NOTICE OF ADDENDUM

ADDENDUM 2

Streets West Facility HVAC and Lighting Upgrade

CONTRACT NO. 9497

2. Replace sheet M 200 with new sheet M 200

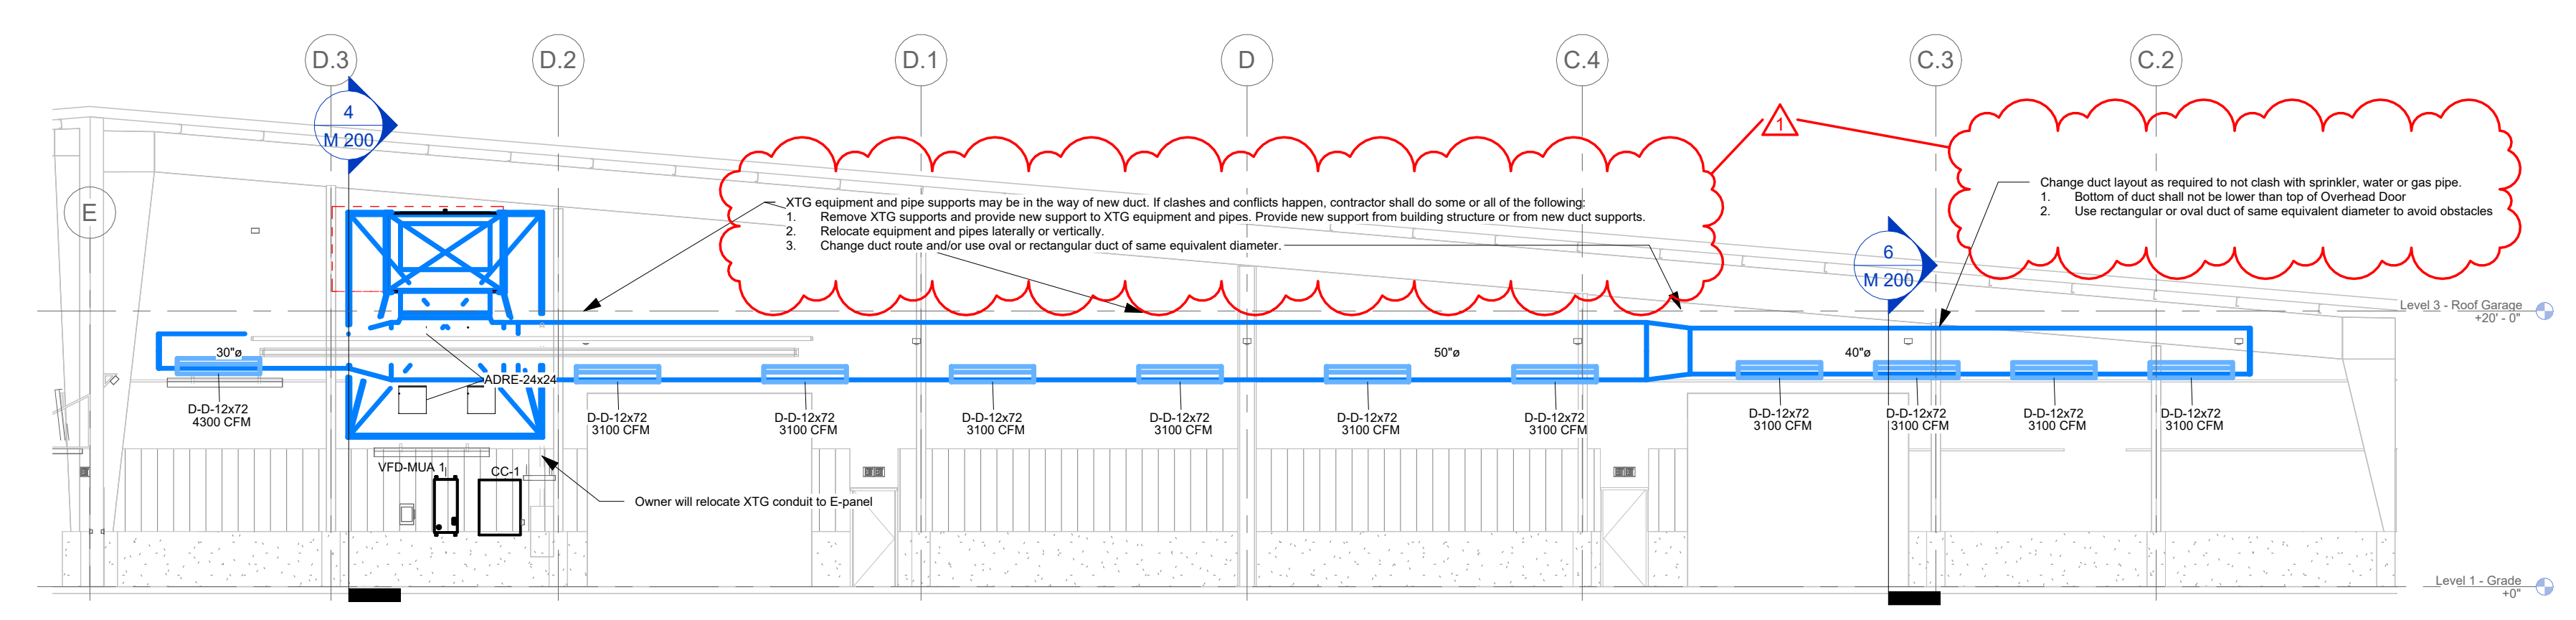
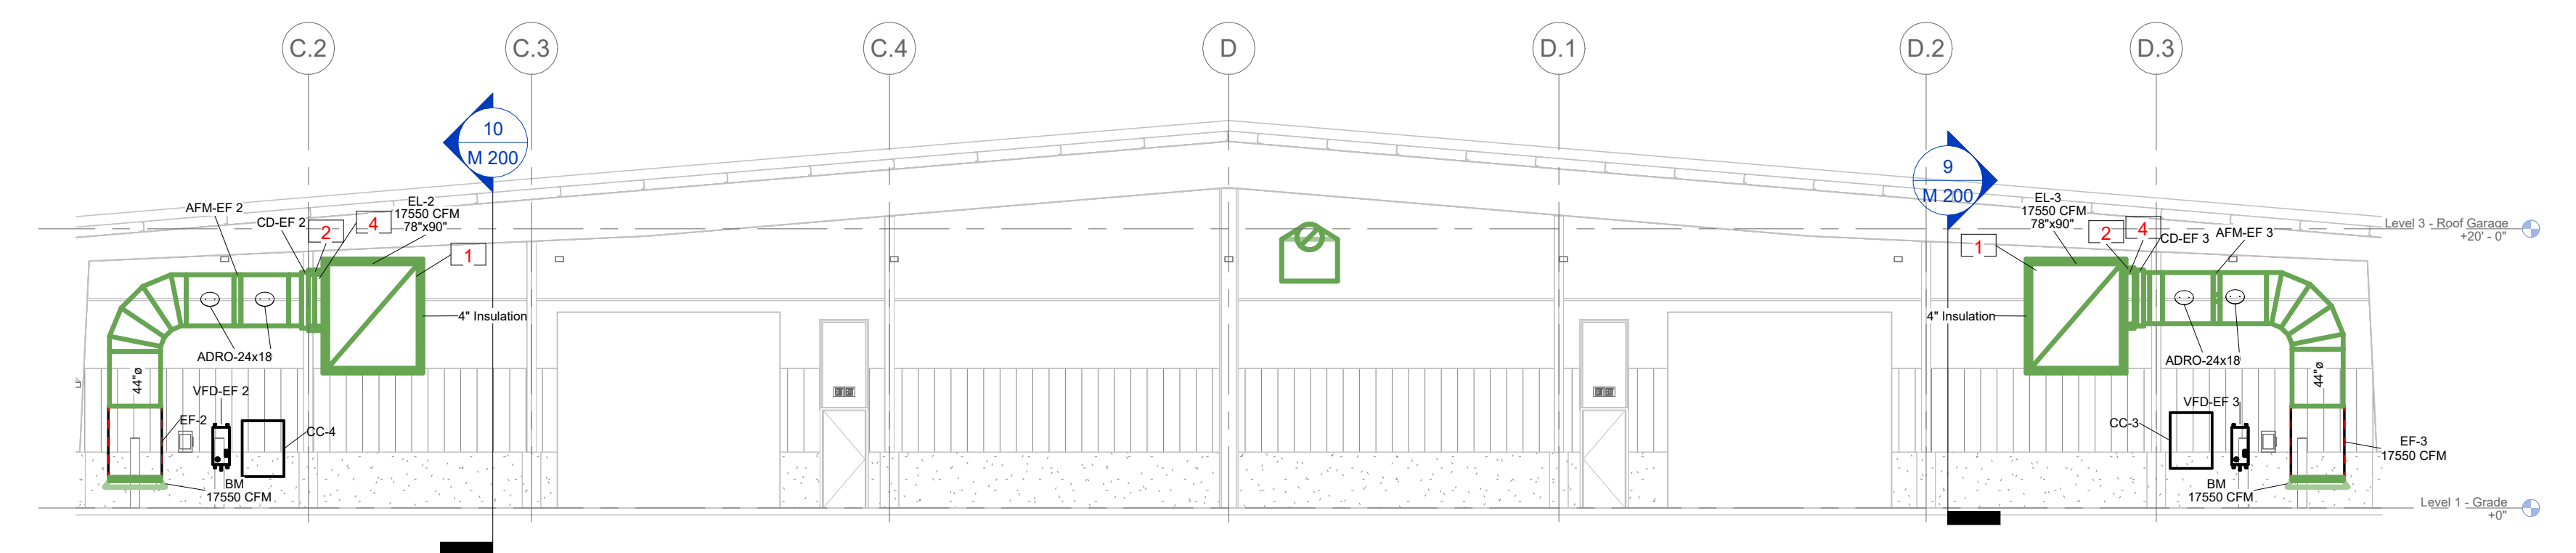
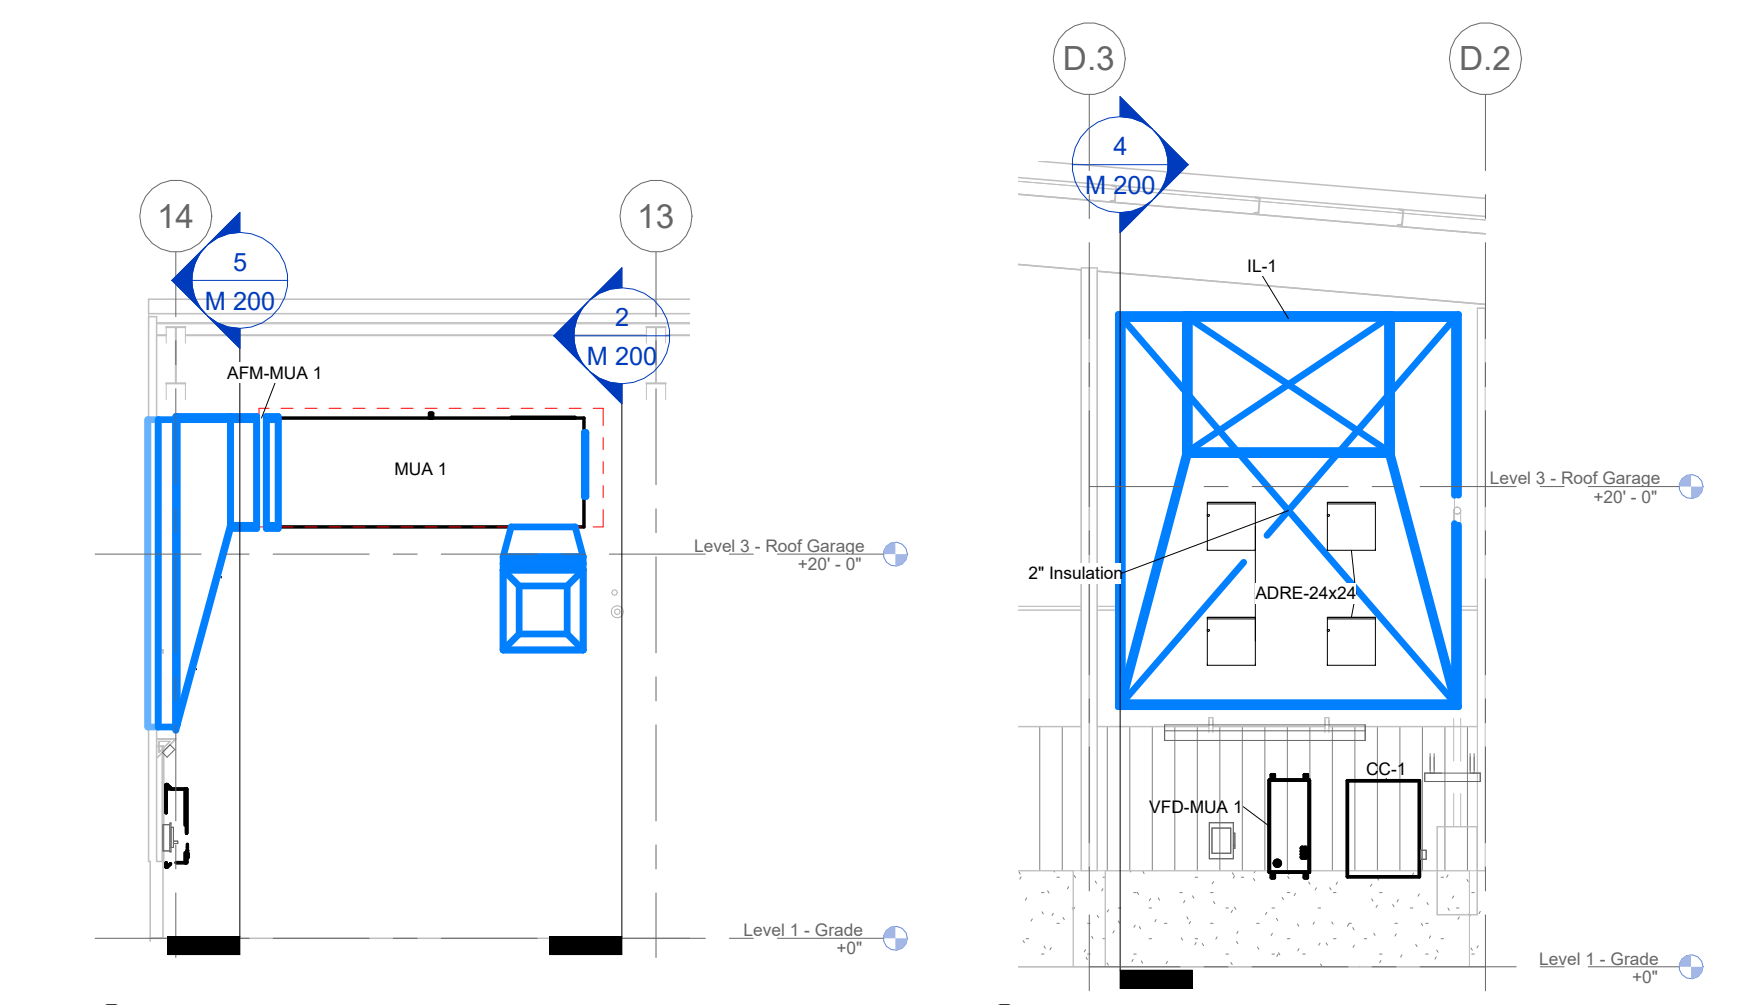
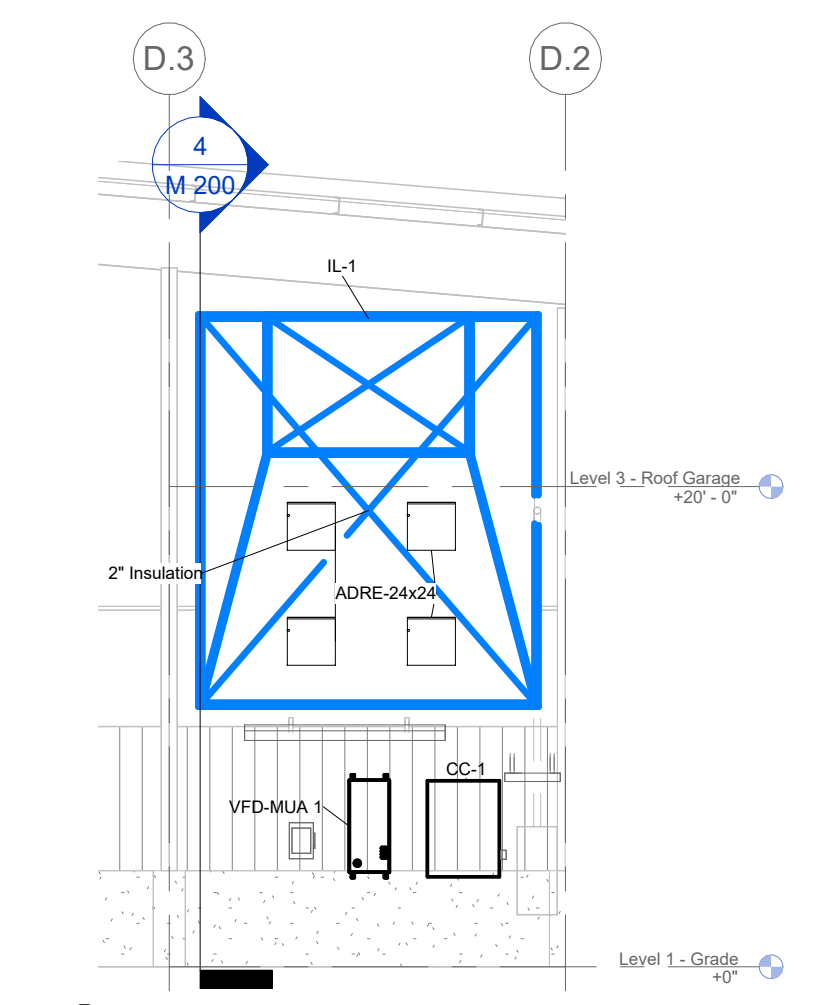
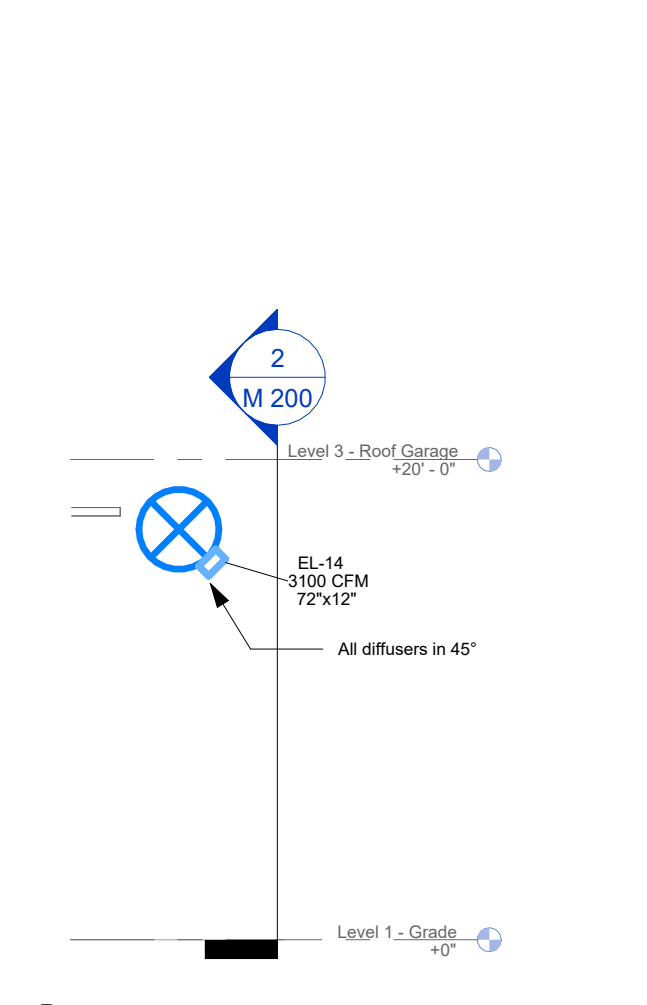
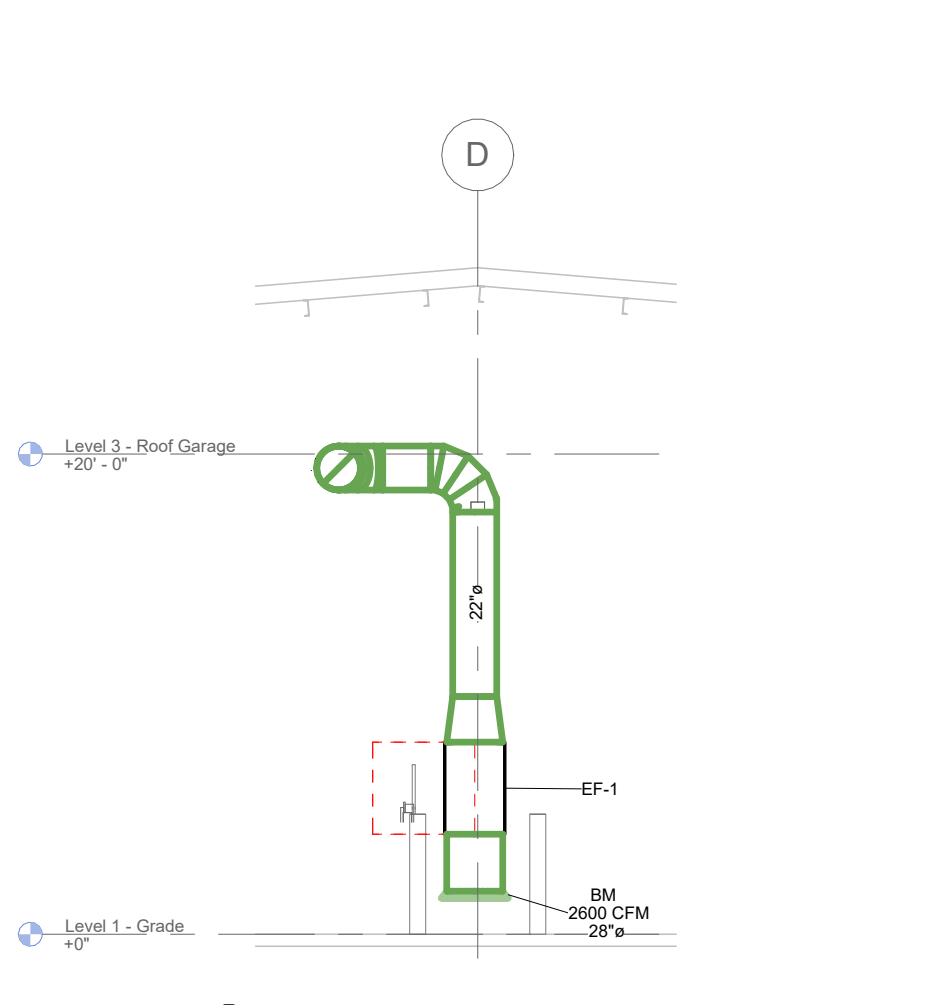
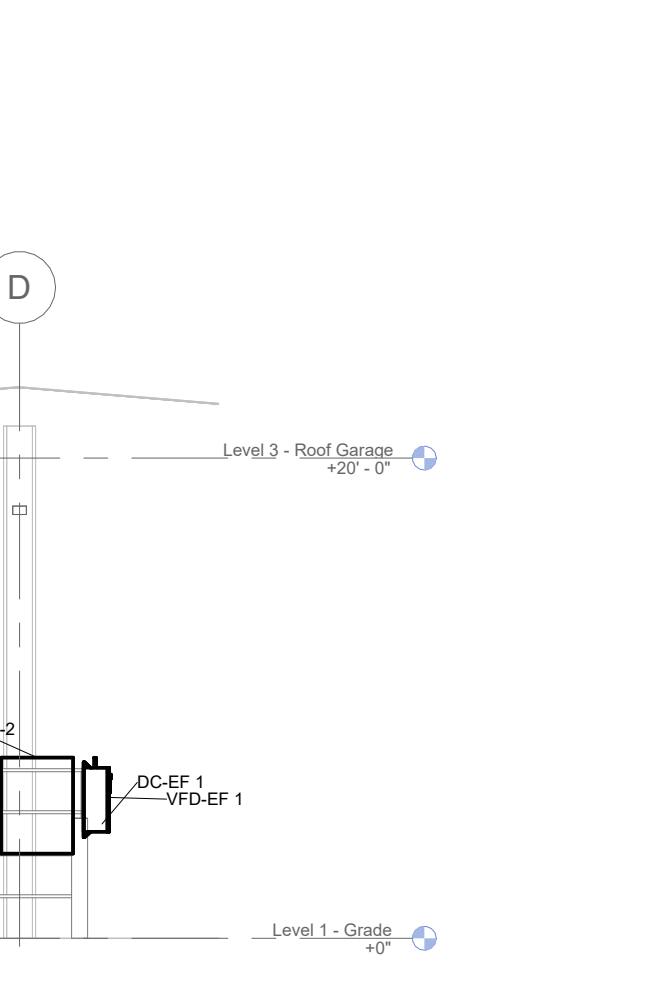
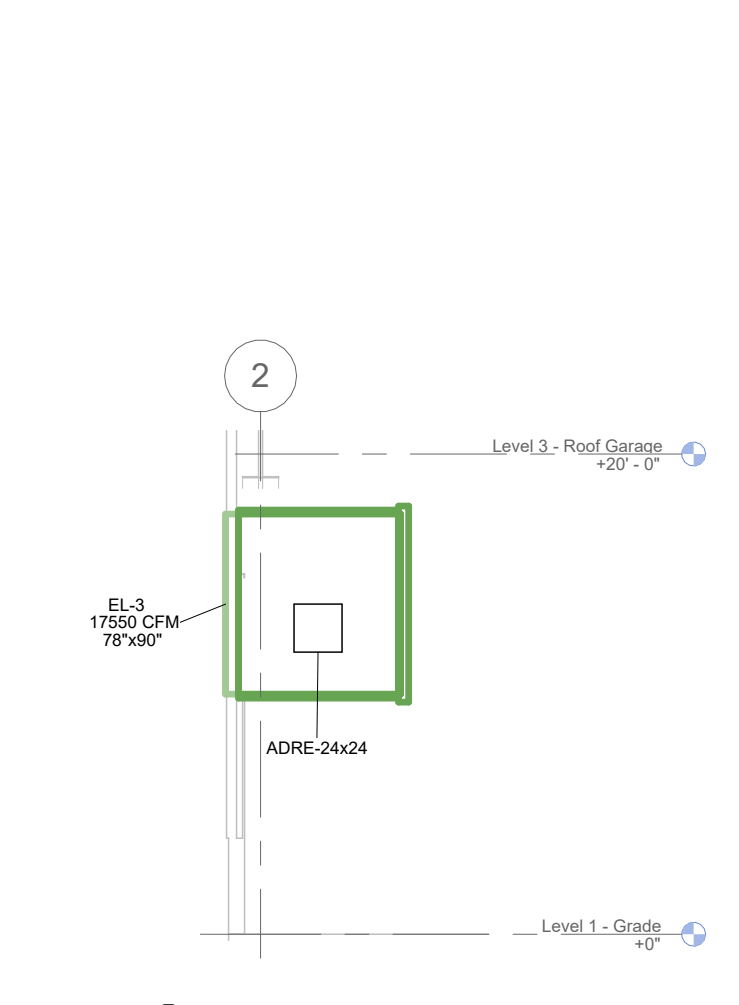
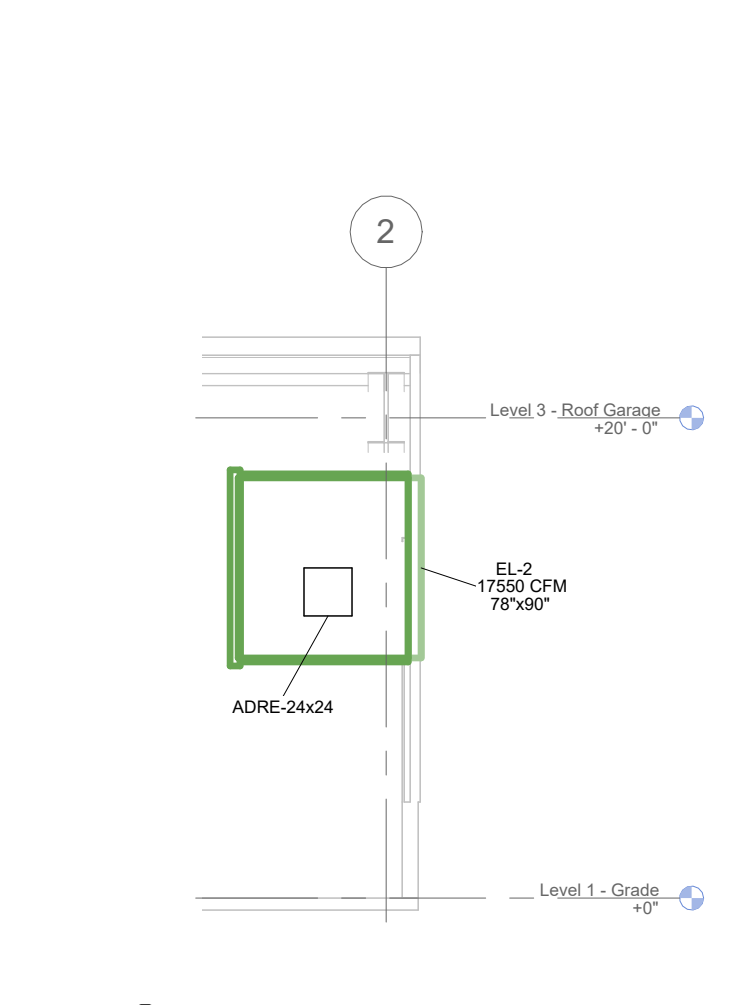
- i. The City will hire a fire sprinkler contractor under a separate contract.
3. Question: "There are sprinkler pipe, gas pipe and radiant heater hangers that may be in the way of the new supply duct. Who will relocate those?"

- a. Answer above question about potential conflict between new supply duct and existing hangers, pipes and equipment.

- a. Answer: Sheet M 200 will be re-issued.
 - i. Contractor shall adjust duct route and elevation to avoid sprinkler pipe, gas pipe and equipment as needed. Use rectangular or oval duct as needed while maintaining same equivalent diameter.

- ii. Where existing gas pipe or radiant heater hangers are in the way, remove supports and provide new support from building structure or from new duct support.

- iii. Duct shall be above Overhead Door height. The air flow and diffuser location shall be as intended in the original design.
4. Question: "Who is a local controls contractor?"
